AAR's Responses to Questions for the Record: Supplementary Information

Hearing entitled, "How the Changing Energy Markets Will Affect U.S. Transportation"
held February 3, 2015, before the Subcommittee on Railroads, Pipelines, and
Hazardous Materials of the Committee on Transportation and Infrastructure

Comments of the Association of American Railroads Before the Pipeline and Hazardous Materials Safety Administration—Docket No. PHMSA-2012-0082 (HM-251): Hazardous Materials: Enhanced Tank Car Standards and Operational Controls for High-Hazard Flammable Trains 61-154

Figure 4. Simulated Train Speed v. Recorded Speed³⁶

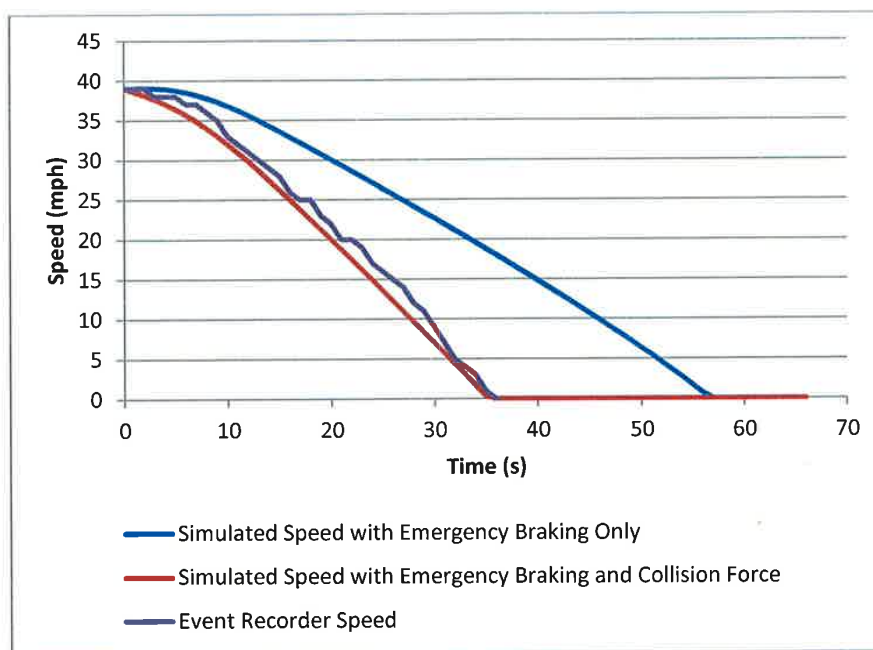
stopping distances modeled compare well to the data from these actual derailments, as shown in Figure 4 below, which compares the speed profile from the event recorder of the remote distributed power locomotive in the Aliceville, Alabama, derailment with the simulated speed accounting only for emergency braking and the simulated speed accounting for emergency braking and the collision force. Figure 4 shows that TTCI's simulated speed, taking into account emergency braking and the collision force, closely tracks the speed shown by the event recorder.

TTCI's model concludes that if ECP brakes had been used in Aliceville, the energy in the derailment would have been reduced by only 12 percent, as compared to the distributed power that was actually used on that train. The model predicts that only 1.5 fewer cars would have reached the point of derailment with ECP brakes.

Figure 5. "Expected" vs. Actual Catastrophic Accidents

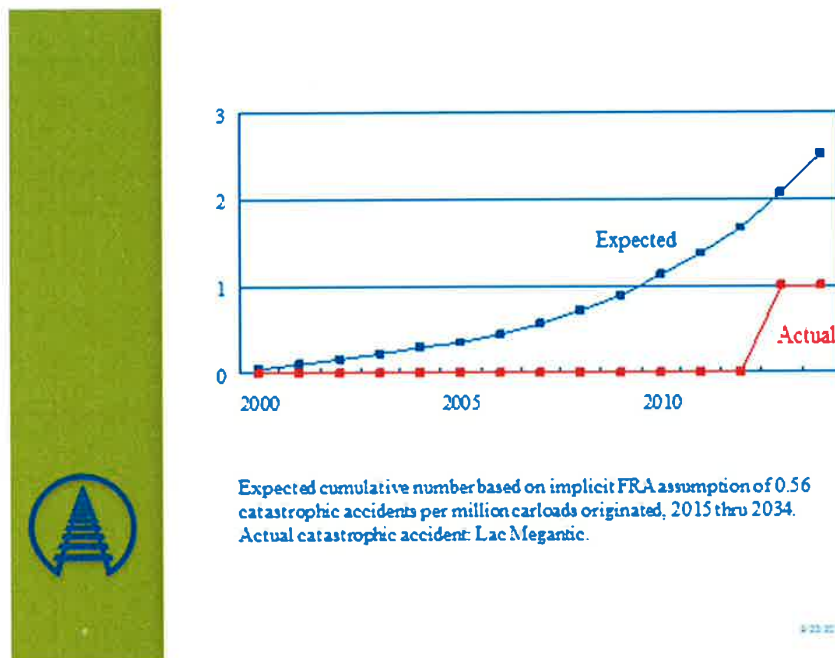
PHMSA's speculation that over the next 20 years the U.S. could experience nine events that would have costs exceeding \$1.15 billion and one exceeding \$5.75 billion is just that – mere speculation. There simply is no basis for such an assumption. Other than Lac-Mégantic, there has been no accident in the catastrophic category.

The railroads' record over the last 15 years does not support PHMSA's speculation. Were the projection of 10 catastrophic accidents over the next 20 years accurate, the catastrophic accident rate would be 0.56 catastrophic accidents per million carloads. If that rate were accurate, there should have been multiple catastrophic accidents in recent years. Figure 5 shows PHMSA's speculation is not borne out by experience.

Figure 4. Force-deflection curves for different tank outage volumes.

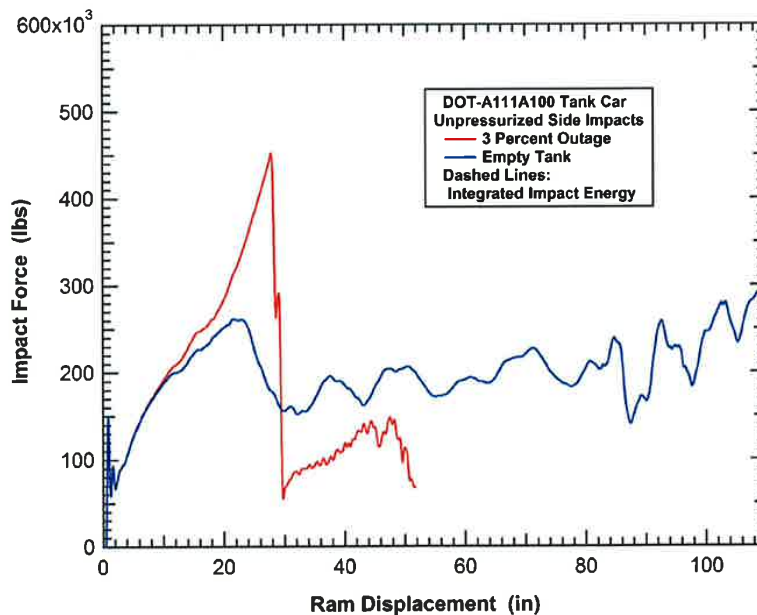
Item 3 – The tank cars used in the derailment simulations were DOT-111 tank cars. The weight of the lading was included in the analyses by increasing the density of the commodity tanks to include the lading weight in the tank shell. However, the additional effect that the compressibility of the lading has on the tank deformations and impact forces was not included in the model. This can be seen in the damage observed in some of the tank cars that include large dents that would not be possible without rupturing the tank to relieve the pressure build up in the lading.

We believe that this approximation could have a significant influence on the calculated impact forces. In particular, the approximation could significantly under predict the impact forces for many impact conditions. Consider the comparison of two analyses with identical impact conditions shown in Figure 4 [9]. The identical tanks were impacted with a 6x6 inch impactor (286,000 lbs) at a speed of 16.2 mph corresponding to an initial 2.5 MJ impact energy from Reference. The tank in both analyses is a DOT 111 tank car design constructed with a 7/16-inch-thick A516-70 steel tank shell. The only difference is that one of the tanks includes the effect of a 3% outage with the internal pressure calculated by a control volume that calculates the compression of the gas in the outage as the tank is dented and approaches a shell full condition. In the second analyses the tank remains unpressurized as if the tank were empty (although the weight of the lading was still smeared into the tank shell to maintain the inertial effects). This second analyses corresponds to the modeling approach used for the tanks in Reference 1.

In the first analysis (red curve), the impact forces begin to rise rapidly after approximately 20 inches of ram displacement to the point where the tank is punctured at a force of approximately 450 kips. With a larger impactor that did not puncture the tank, the forces would have continued to rise rapidly to significantly higher levels. The second impact response of the “empty tank”, modeled without the lading compressibility effects, deforms the tank in excess of 100 inches without the impact force ever exceeding 300 kips (blue curve). Thus, not including the lading compressibility effect could significantly bias the analysis of the force distribution in Reference 1 toward a lower impact force distribution.

Figure 5. Derailment simulation for Scenario 2 at 40 mph from Reference 1.

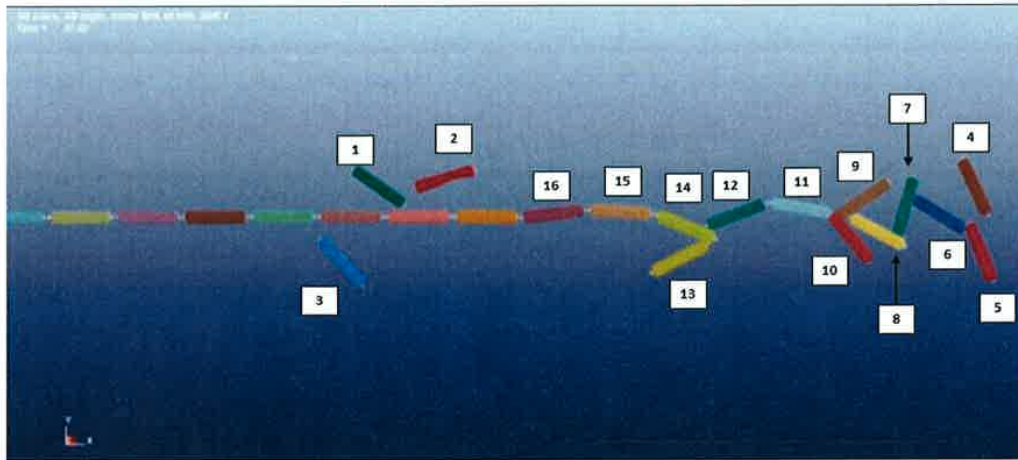
Although the Federal Railroad Administration (FRA) data in Figure 8 of Reference 1 shows a scatter of derailed cars at 40 mph to vary from 1 to 43 cars, this variability is understandable given the wide range of derailment scenarios possible. A single car may derail from a broken wheel or axle but remain coupled to the cars ahead and behind the derailment point so that it is the only car that derails. Alternatively the other factors such as terrain or grade, the point in the train where the derailment initiates, ground conditions, etc. could result in significantly more or less cars being derailed at a given derailment speed.

From the parameter variation described in Reference 1 (listed above) we believed that the track interaction was the most significant factor that would influence the variability seen in number of cars derailed. To better understand the derailment mechanics, we attempted to identify the

response with only 16 cars derailed and believe it is the top row center case shown in Figure 4 of Reference 1. We have reproduced the final state for that scenario in Figure 5 adding numbers counting the cars we believe to be derailed.

Obviously the simulation was performed with the train moving from left to right in Figure 5. However the final state indicates that Cars 1, 2, and 3 have derailed and came to rest at a position that is behind a point where other cars are still on the rail. This indicates that the simulations do not include any feature for a mechanism such as a broken rail where every car passing beyond that point is automatically derailed. In these simulations, cars can be pushed out of the way of the remaining cars without damaging the track so that subsequent cars are only derailed when their lateral forces exceed the “track quality” strength values.
